Proposed Revisions to a Standard Plans Index

Index Number: 430-001

Index Title: Miscellaneous Drainage Details

LIMITS OF VARIABLE FRONT SLOPES AT DRAINAGE STRUCTURES

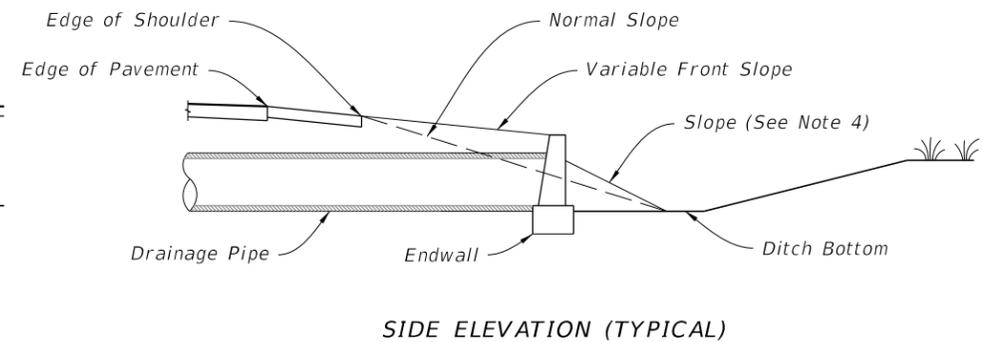
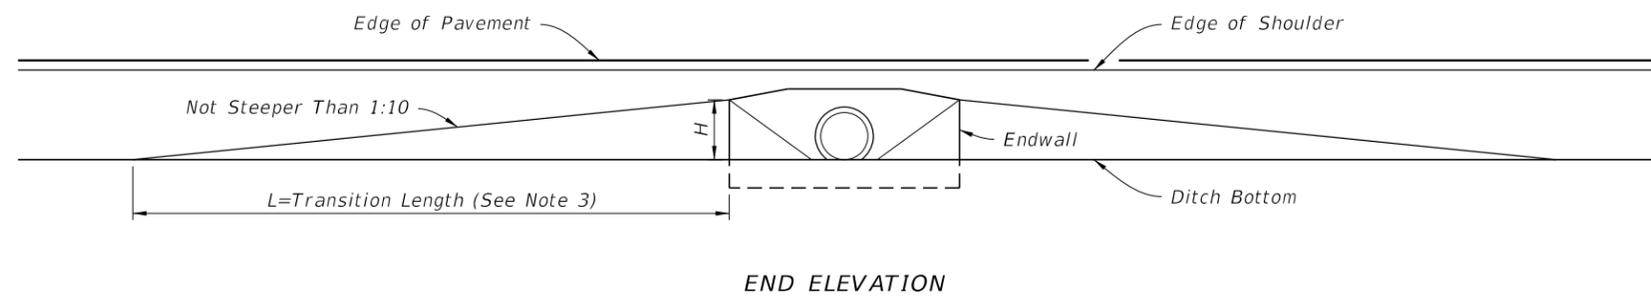
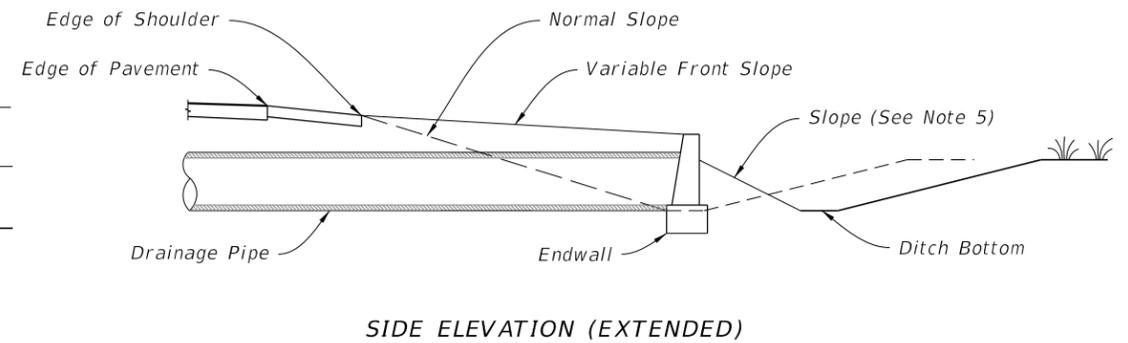
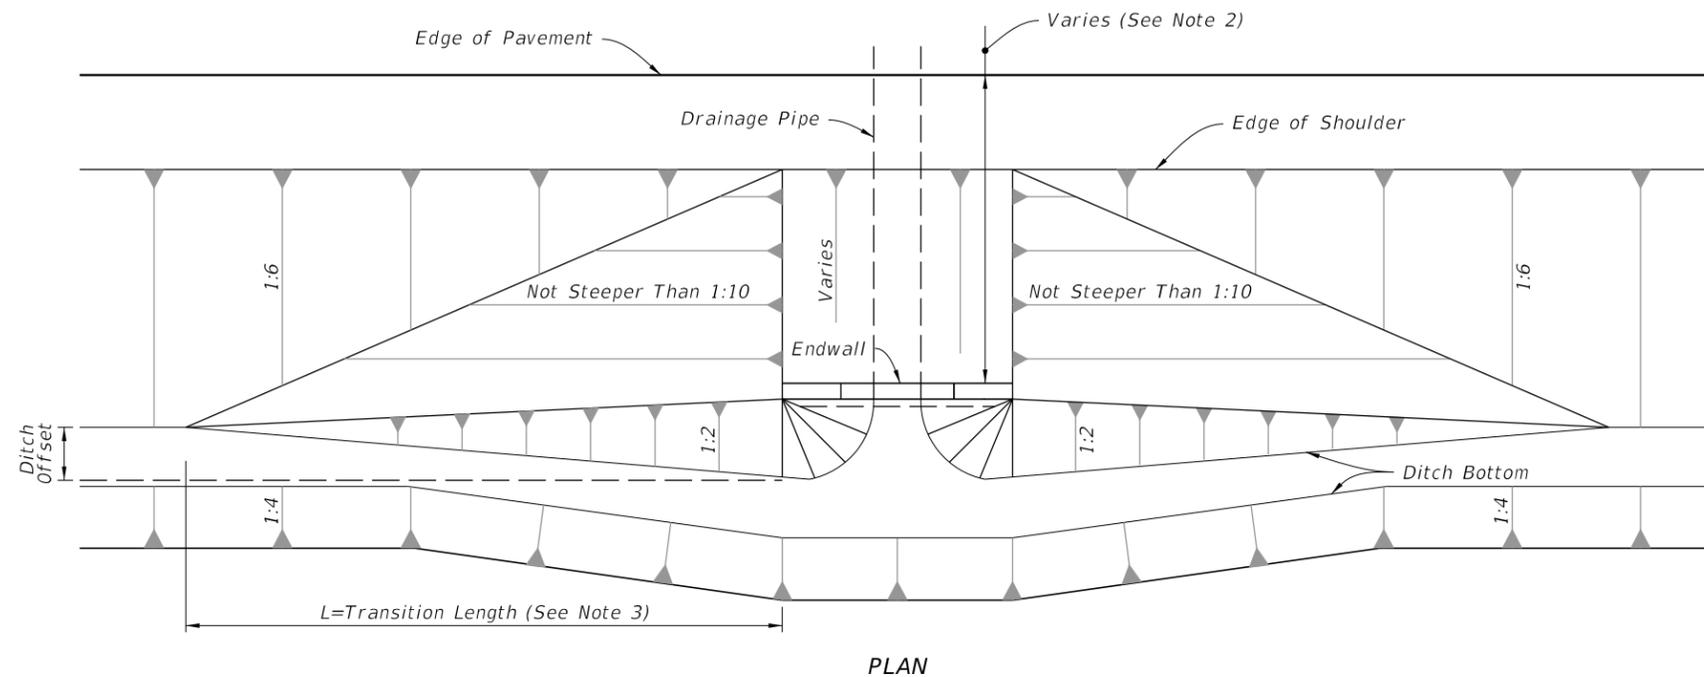
Sheet 1: Updated Table of Contents to reflect title change on Sheet 3.

UPDATED TITLE: Geotextile

ROUND AND ELLIPTICAL CONCRETE PIPE JOINT

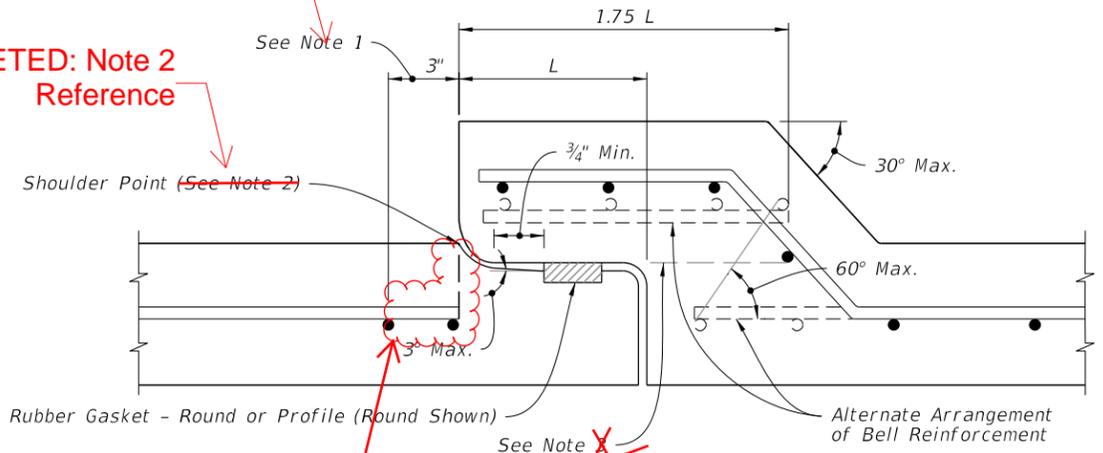
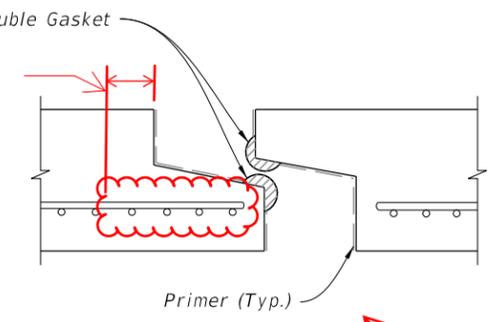
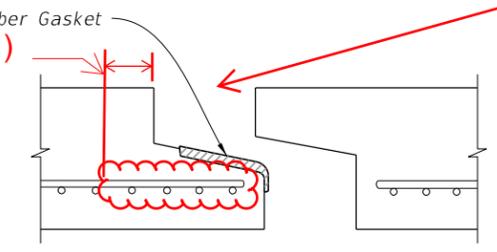
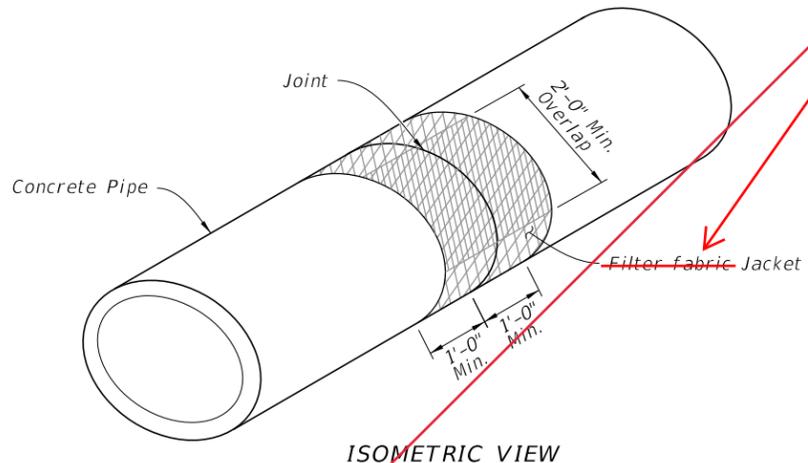
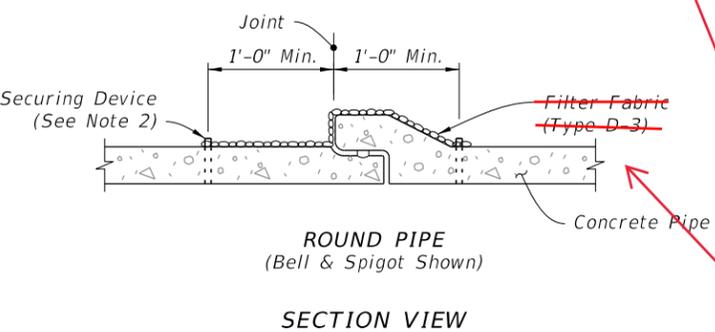
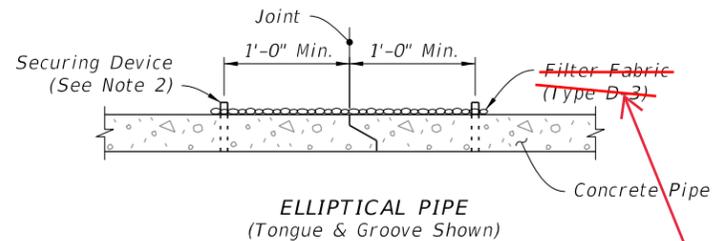
DELETED: Note 2 Reference

UPDATED DETAILS:
To show 3" dimension;
added Note 1 reference;
deleted rebar to 3" dimension

ADDED: New Note 1
Locate the last full wrap of reinforcement
within 3 inches of the spigot shoulder and
meet ASTM C507 for elliptical pipe.

UPDATED: Note 2
Type D-3 Geotextile

Deleted Note 1 and 2

UPDATED: "Joint is homed."

ADDED: New Note 1
Locate the last full wrap of reinforcement
within 3 inches of the spigot shoulder and
meet ASTM C76 for round pipe.

Deleted Notes 1 and 2 on Round Concrete Pipe Joint Detail; Added new Note 1 "Allowable tolerance for the last full wrap of circumferential reinforcement shall be within 3 inches from the spigot shoulder and meet ASTM C76 for round pipe or ASTM C507 for elliptical pipe."; renumbered notes on Elliptical Concrete Pipe Joint Detail; Updated Note 3 on Elliptical Concrete Pipe Joint Detail; Updated Profile Rubber Gasket and Preformed Plastic Joint to show 3" dimension and added Note 1 reference; deleted rebar to 3" dimension on all details; deleted Note 2 reference and changed "See Note 3" callout to "See Note 2" on Round Concrete Pipe Joint Detail

A search in ASTM archives shows that the "within 3 inches of spigot shoulder" language has existed since about 1985 in both C76 and C507. Our standard Plans were updated in 2004 which moved the last wrap from inside the joint to the shoulder, but it is unknown why the 3" guidance was omitted. This change brings the Standard Plans in line with the ASTM specifications.

FILTER FABRIC JACKET, CONCRETE JACKET, AND PIPE PLUG

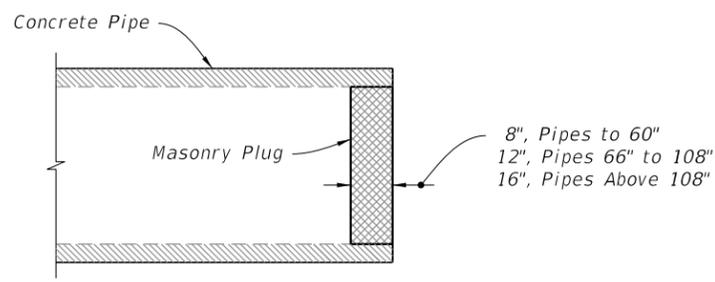
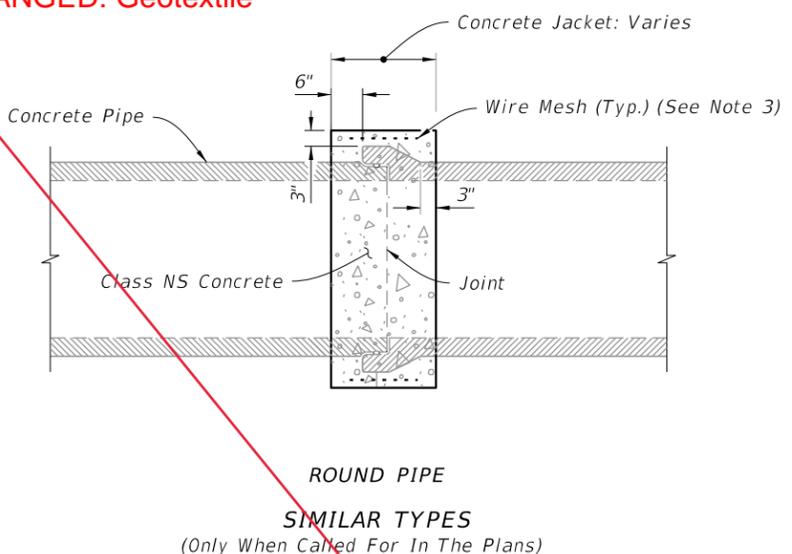
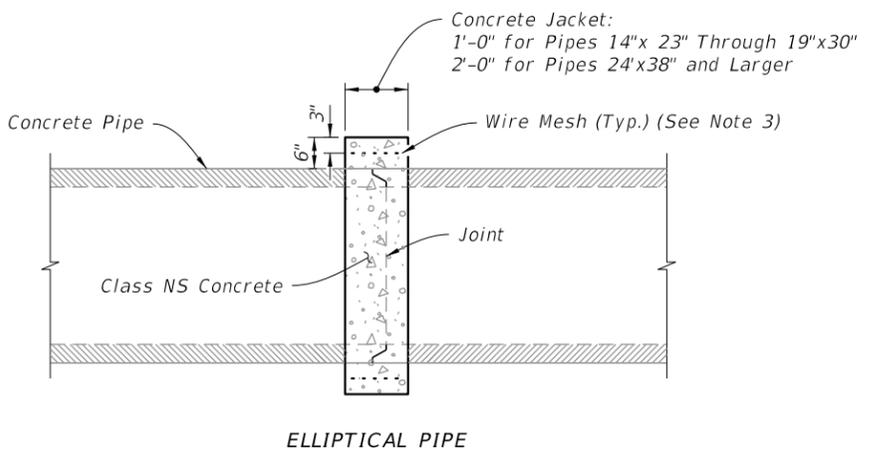
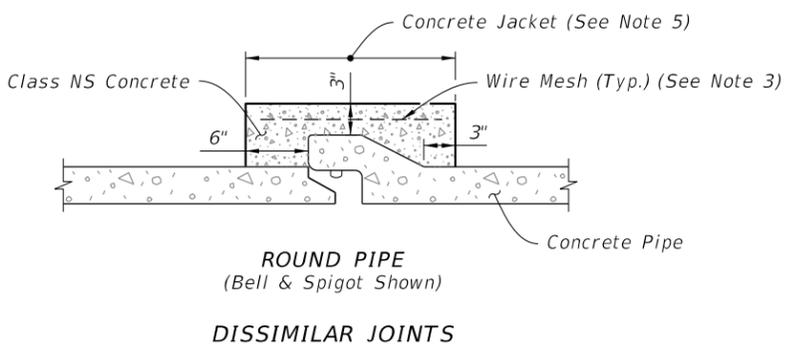
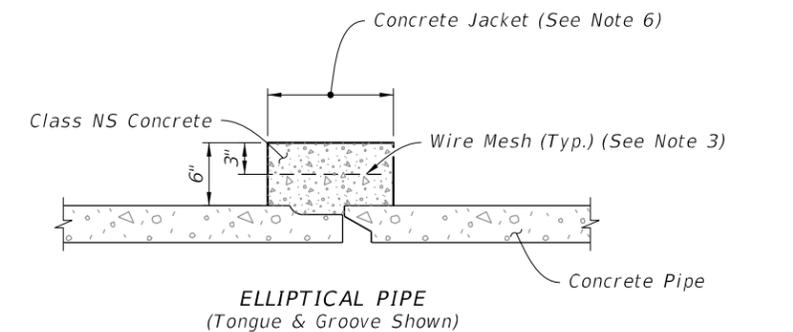
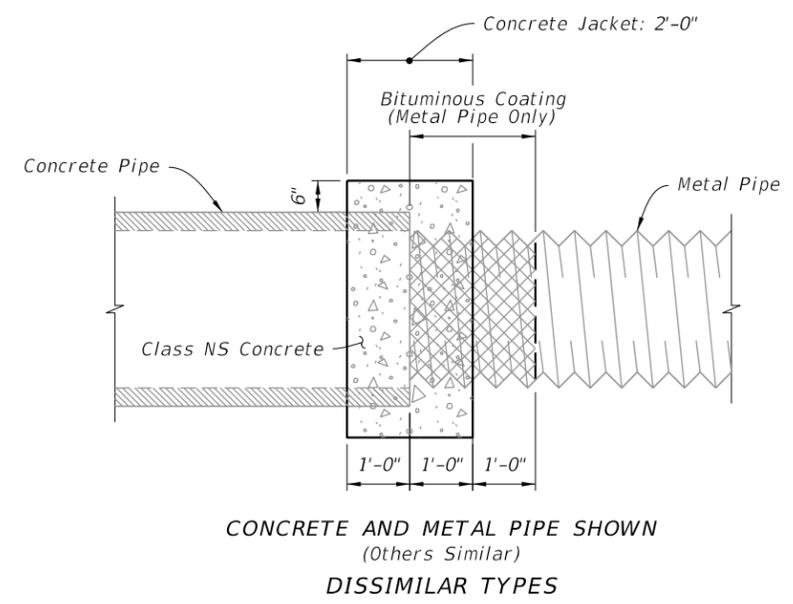
CHANGED: Geotextile

UPDATED Note 2: Install Type D-3 geotextile in accordance with Specification 514. Install securing device to hold the geotextile jacket on to the pipe.

Sheet 3: Updated Note 2 "Install Type D-3 geotextile in accordance with Specification 514. Install securing device to hold the geotextile jacket on to the pipe." ; Changed all references of "Filter Fabric" to "Geotextile".

ROUND AND ELLIPTICAL CONCRETE PIPE JOINT

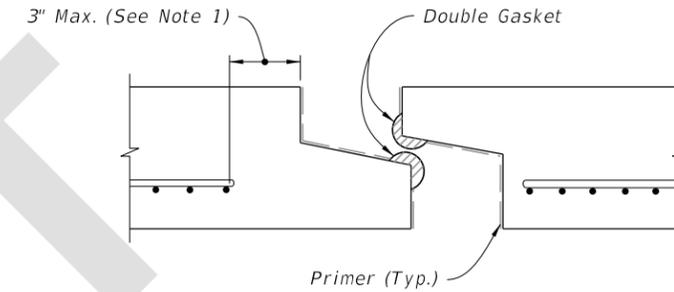
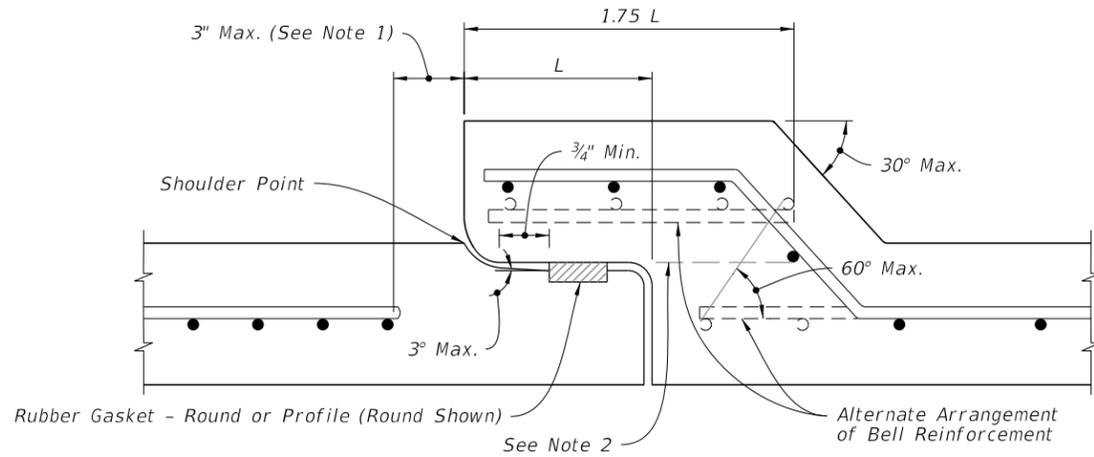
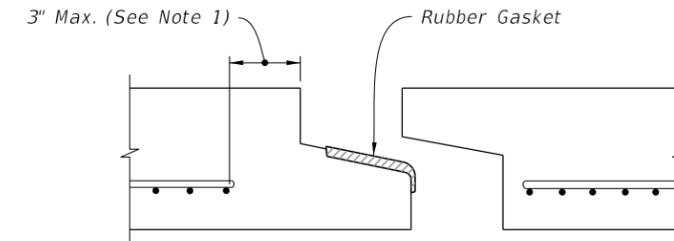
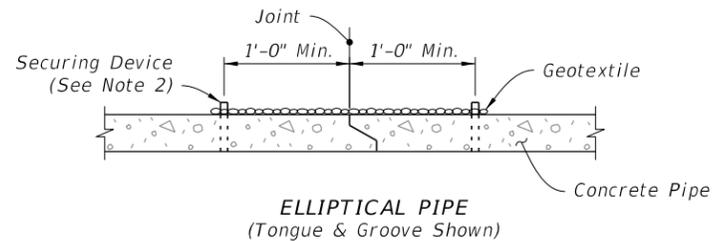
1. Locate the last full wrap of reinforcement within 3 inches of the spigot shoulder and meet ASTM C76 for round pipe.
2. All circumferential steel located above this line and within the 1.75 L is defined as bell reinforcement.

1. Locate the last full wrap of reinforcement within 3 inches of the spigot shoulder and meet ASTM C507 for elliptical pipe.
2. Type D-3 Geotextile Jacket is required on both type of joints.
3. Details shown before joint is homed.

GEOTEXTILE JACKET, CONCRETE JACKET, AND PIPE PLUG

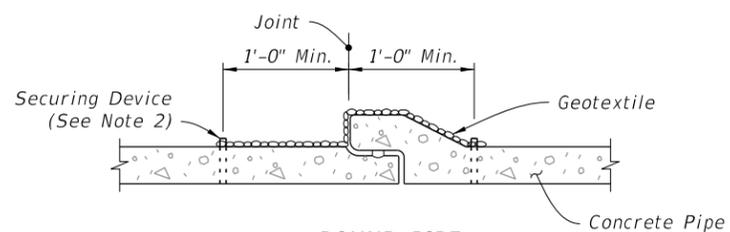
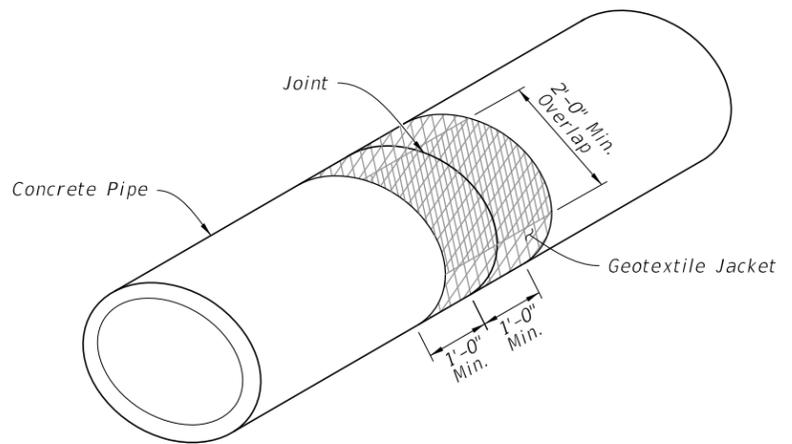
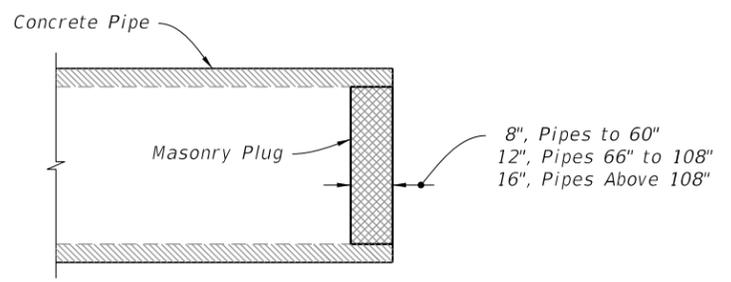
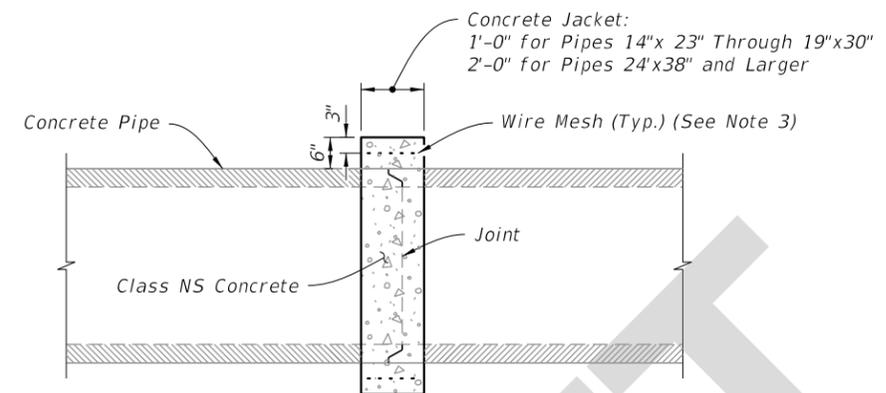
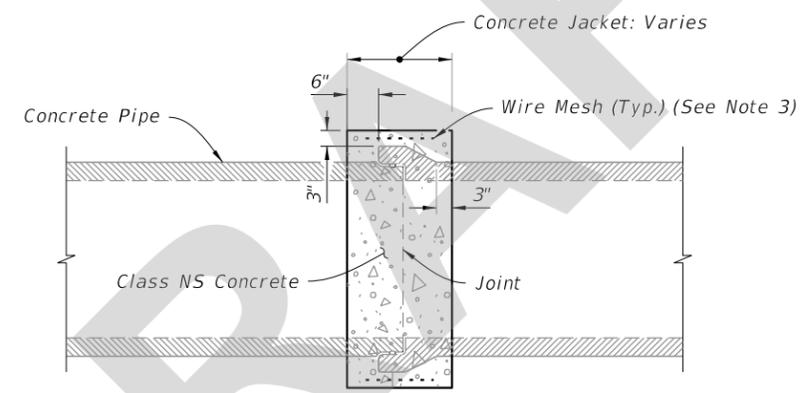
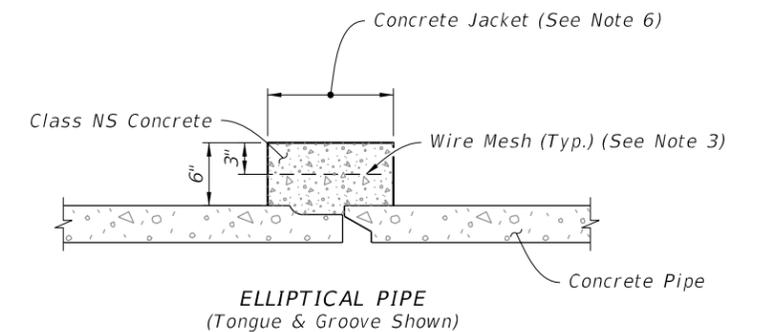
1. Alternate connection must be approved by the Engineer.
2. Install Type D-3 geotextile in accordance with Specification 514. Install securing device to hold the geotextile jacket on to the pipe.
3. Any wire mesh arrangement which provides 0.126 square inches of steel area per linear foot both ways may be used, provided the wires are spaced a minimum of 2" and/or a maximum of 6" on centers.
4. Do not use a concrete jacket to join dissimilar metal pipes.
5. 12" for pipes 15" through 24"; 24" for pipes 30" and larger.
6. 12" for pipes 14" x 23" through 19" x 30"; 24" for pipes 24" x 38" and larger.
